STATUS CODE DESCRIPTION
ISSUED FOR FURTHER INFORMATION

PROJECT
ADAMSTOWN STATION BLOCKS ACD

DRAWING
BLOCK D ELEVATIONS

PROJECT NUMBER	DATE	
950747	08/04/22	
SCALE@ A1:	DRAWN/CHECKED:	
As Indicated	FM/RJ	
STATUS CODE:	DRAWING NUMBER	REVISION
A1	ADC3-HJL-ACD-ZZ-DR-A-P2014	P02

3 Block D - South Elevation
1 : 200

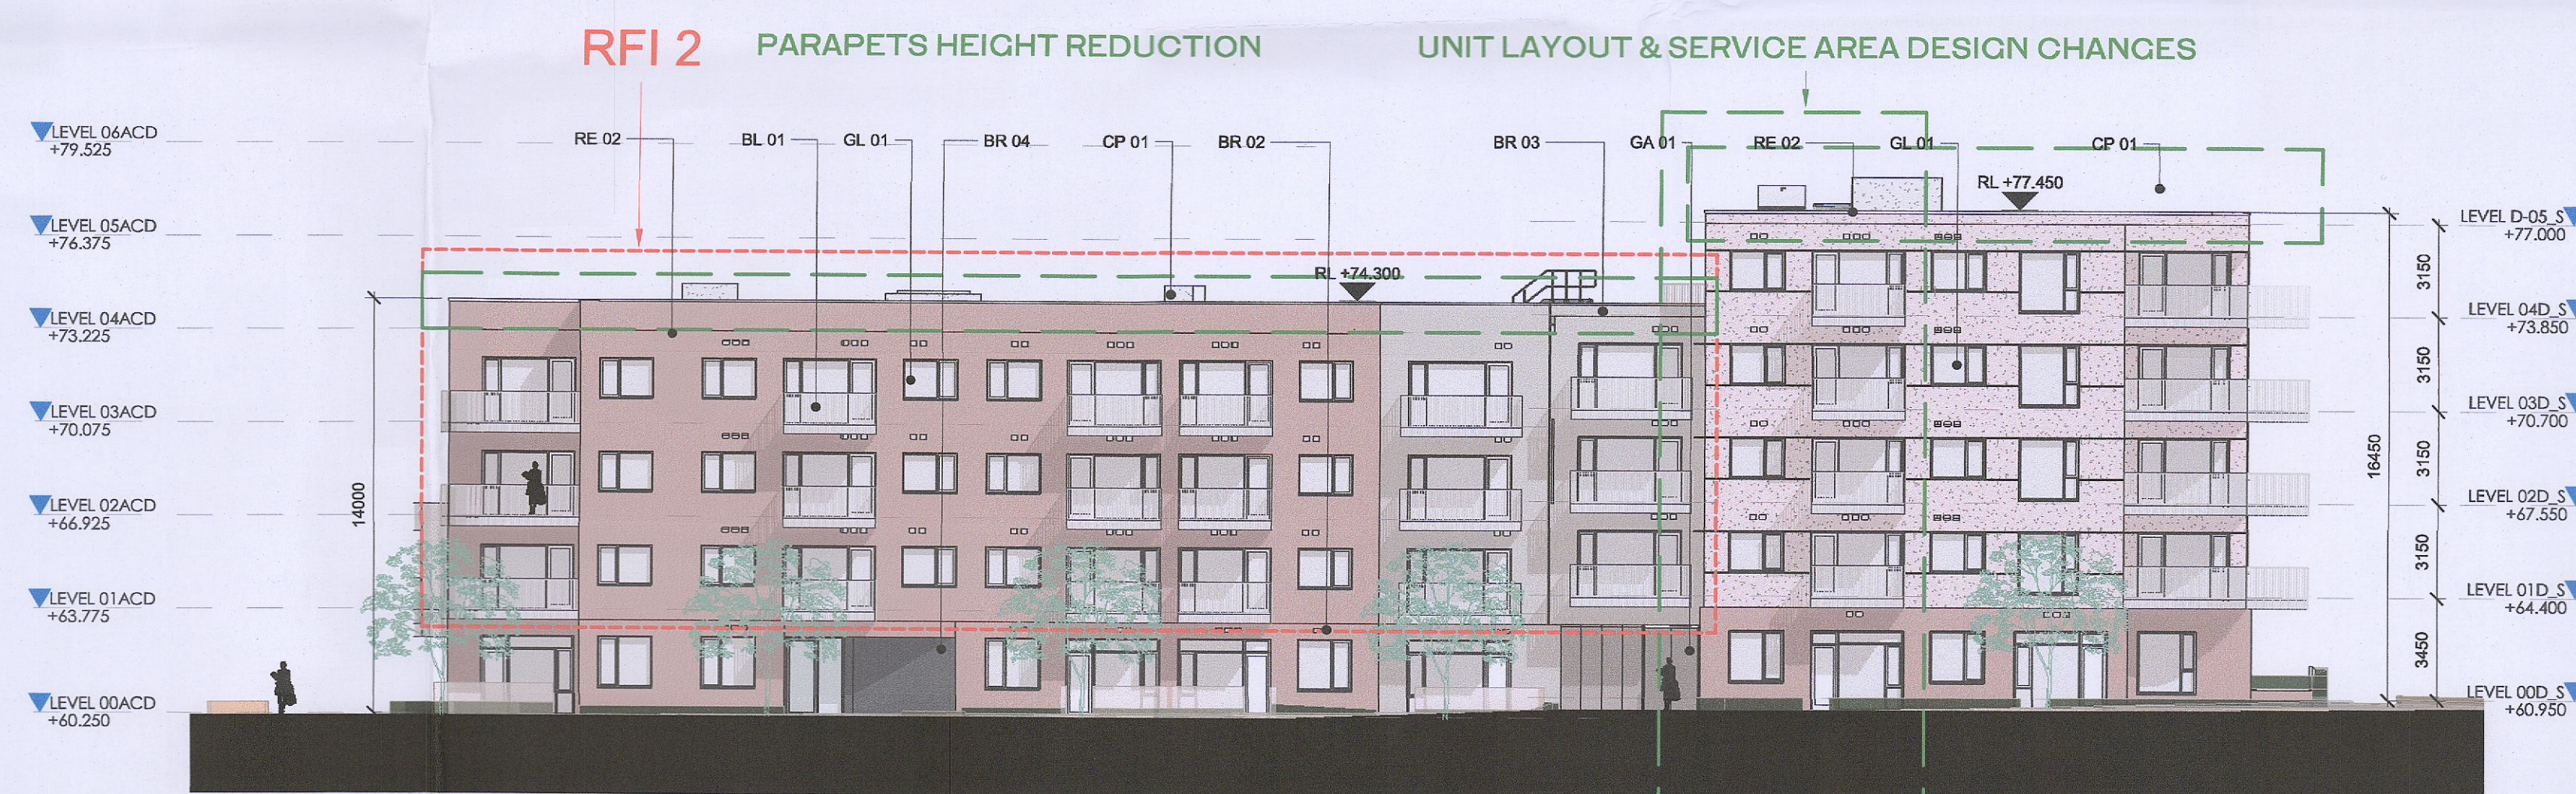
- RFI 1(a)**
Block D North - Changes to Core entrance hall facing Great Western Way updated to accommodate new apartment type T.301_D revised apartment type T.102_D
- RFI 1(b)**
Block D South - Changes to apartment type T.201_D and T.202_D to overcome privacy/overlooking issues
- RFI 2**
Block D South - Changes to facade material to brick on the upper floor levels
